Docket Item # 11
BAR CASE # 2007-0230

BAR Meeting
December 6, 2007

ISSUE: Additions and alterations

LOCATION: 113 South Lee Street

Figure 2: Proposed Side Elevation

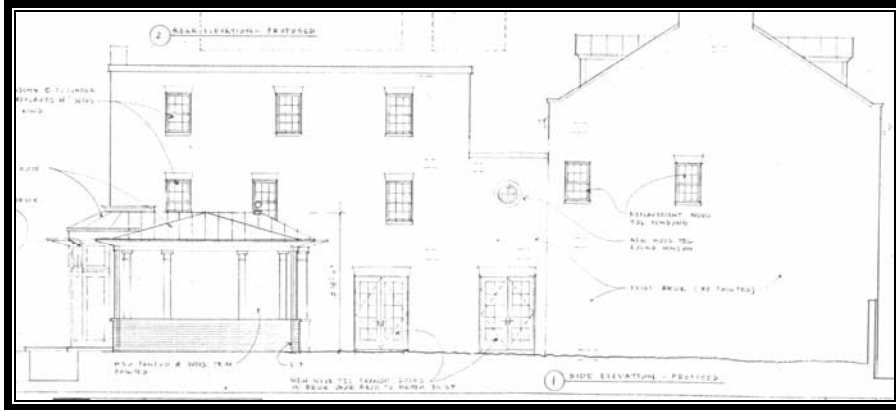
However, staff continues to be opposed to the enlargement of the existing window on the north side of the historic main block because it will alter the visual integrity of the existing elevation.

Staff has no objection to the re-creation of the second story porch and the associated alterations on the north side of the rear addition. There is clear physical as well as documentary evidence to indicate the size and location of the previously existing porch. The new porch will essentially mimic the size and location of the porch that had existed at this location. The new porch utilizes design elements and materials found in abundance throughout the historic districts.

Figure 3: Proposed Side Elevation

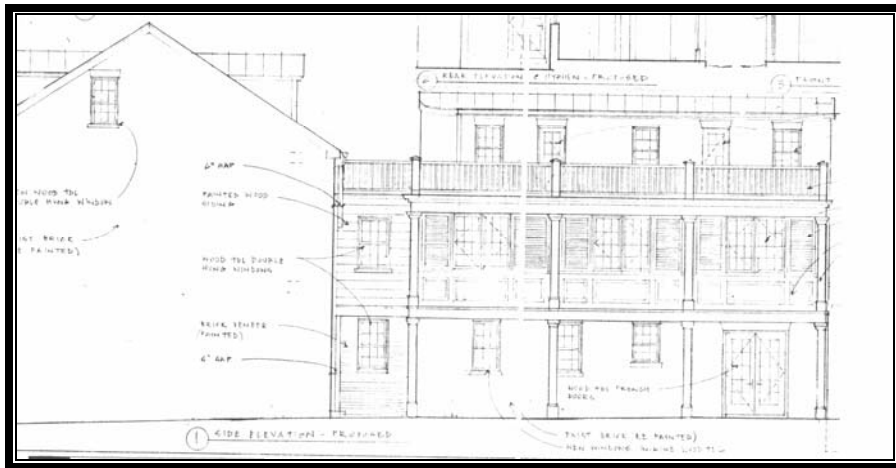
The parti of the new one story addition is similar to a number of other additions to early houses with large adjacent side yards and was most recently approved by the Board for the freestanding house at 617 South Lee Street. The design of the addition utilizes a pavilion form and a traditional building vocabulary and materials. The relationship of solid to void is greater than that found on early 19th century houses, but mimics a number of additions that have been approved by the Board in recent years. Staff also notes that this addition is minimally visible from the public right-of-way and the most prominent element from the street will be the roof form. Thus, staff supports the design of this portion of the additions and alteration.
